Update to Bid Documents – May 20, 2025

VAMC St. Cloud, MN
Remodel Building 51-1 Eastside
4801 Veterans Drive
St. Cloud, MN 56303

VA Project 656-19-307
May 20, 2025
Update to Bid Documents

DRAWING TITLE
FIRST FLOOR SYSTEMS PLAN - ZONE 1

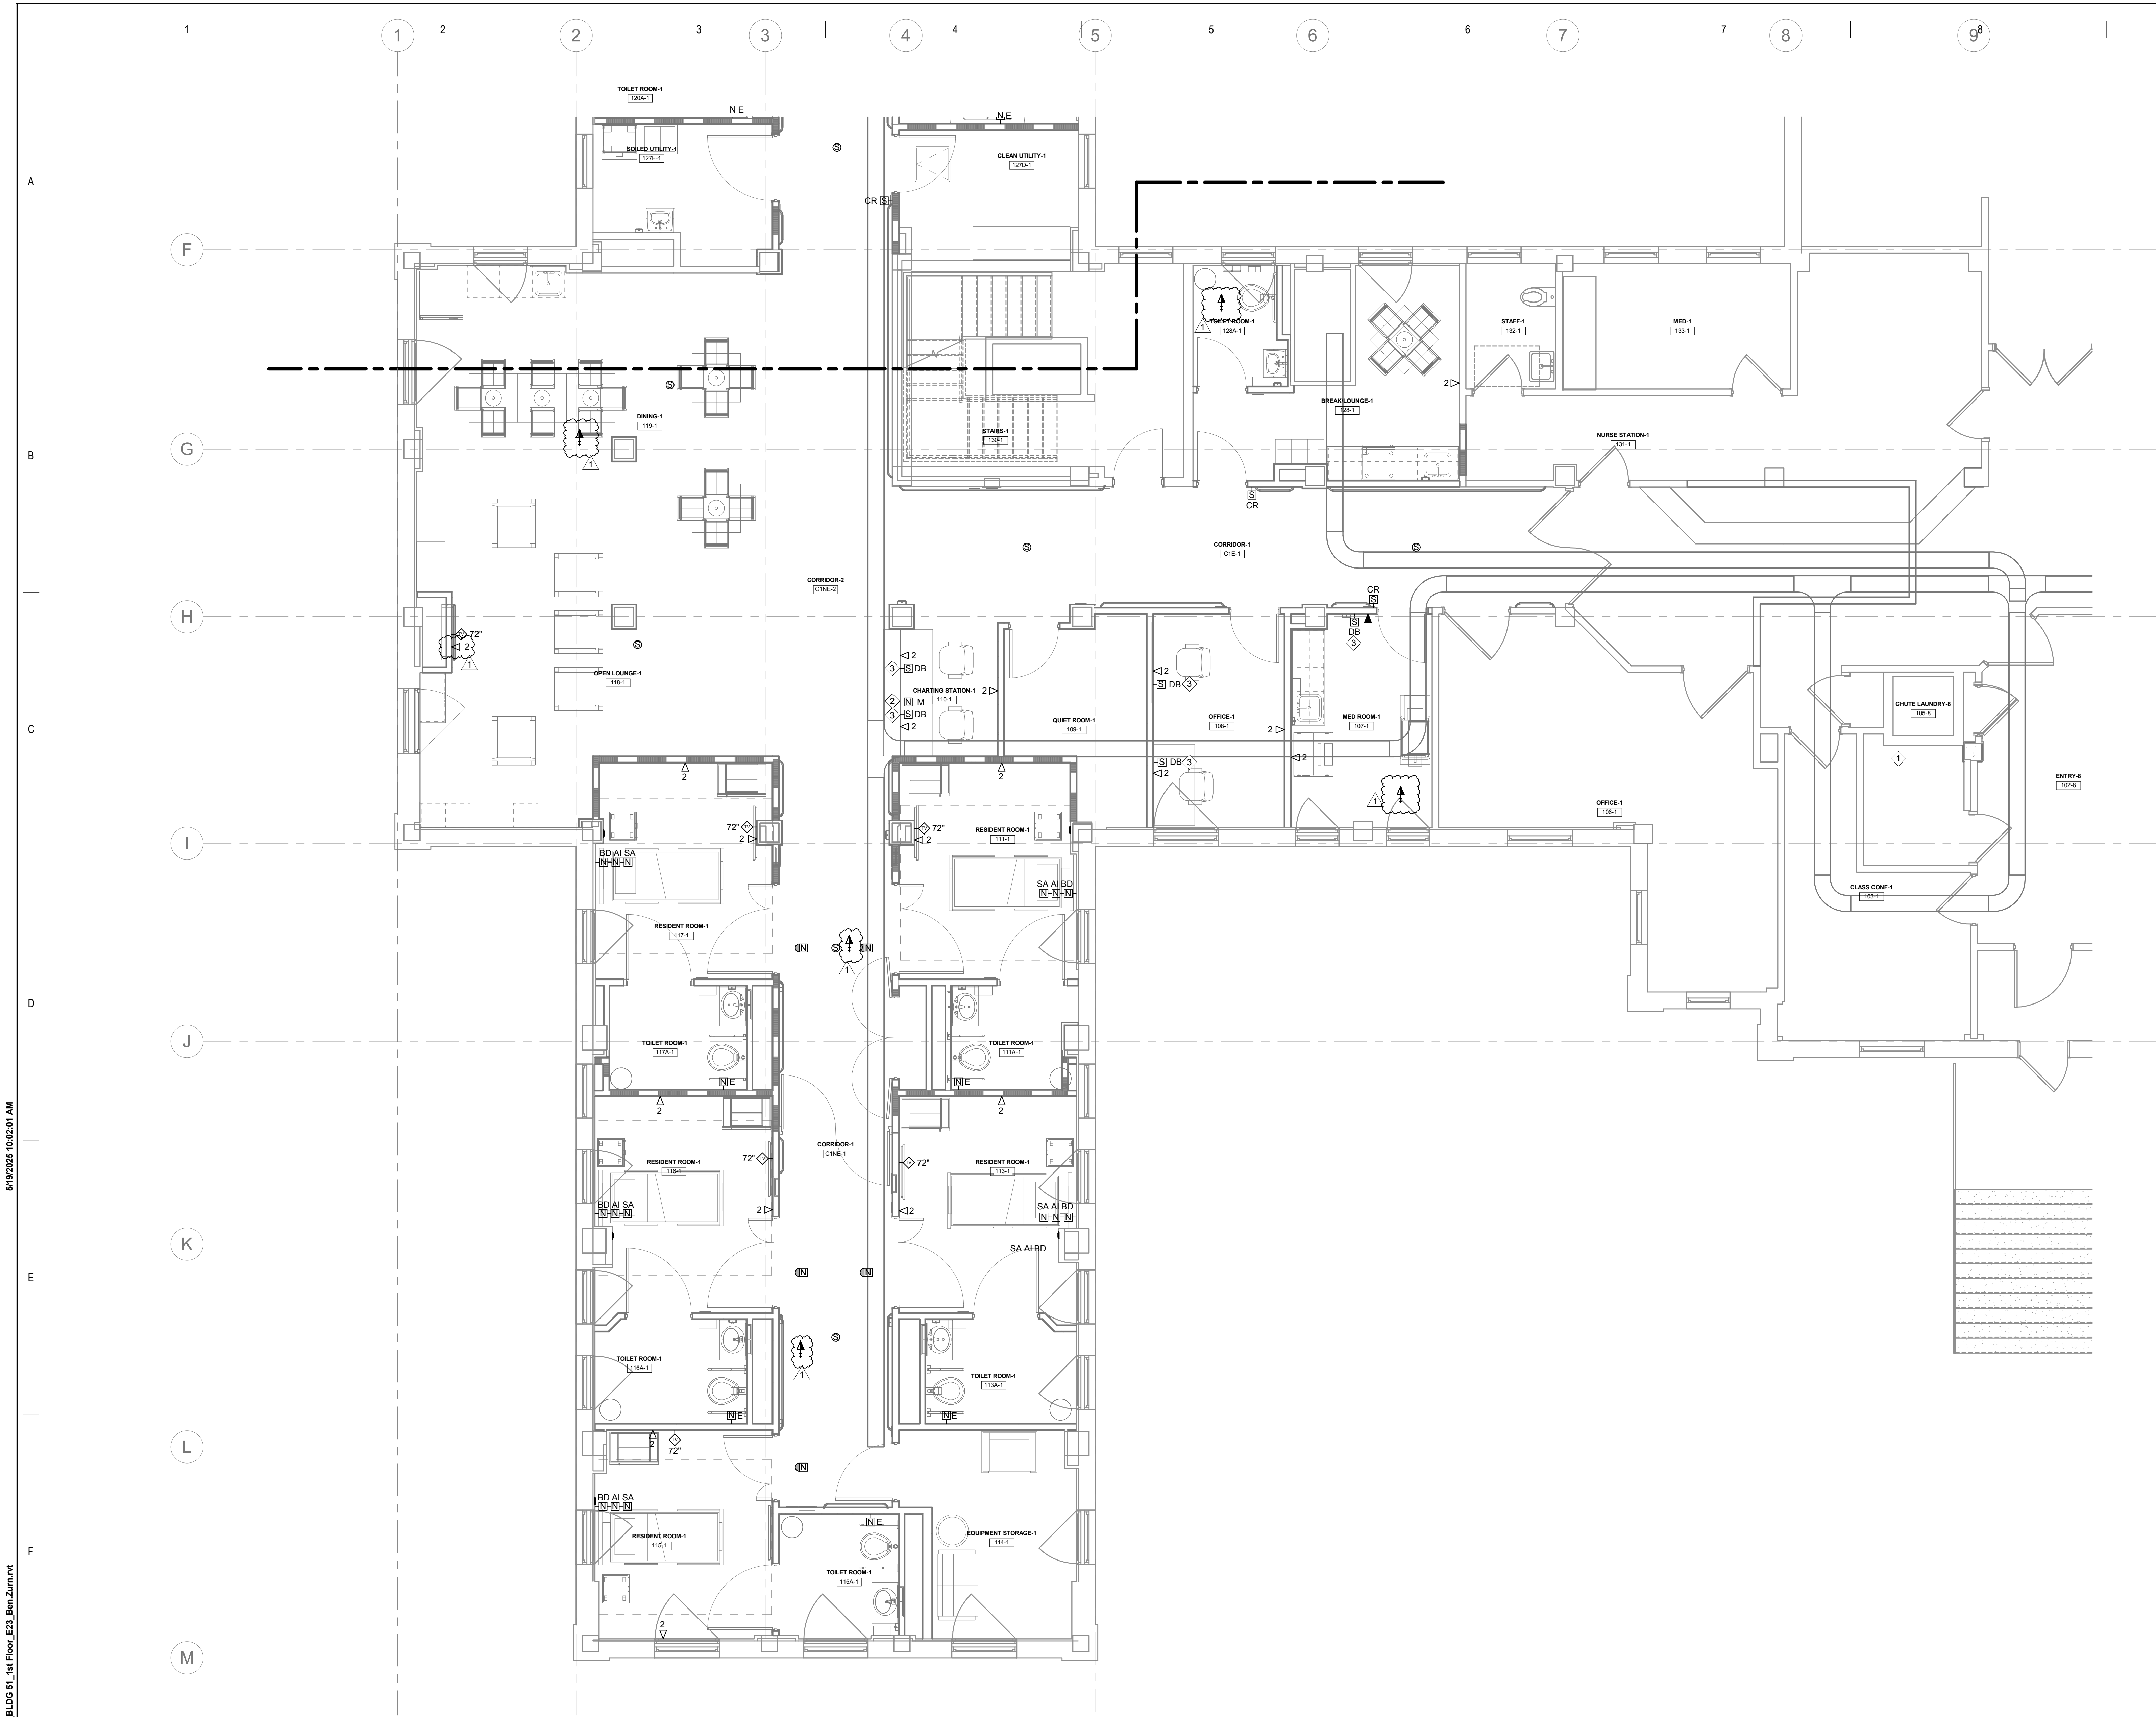
- 23. Sheet 51-ES110
 - a. Show WAP locations
- 24. Sheet 51-ES110
 - a. Show WAP locations
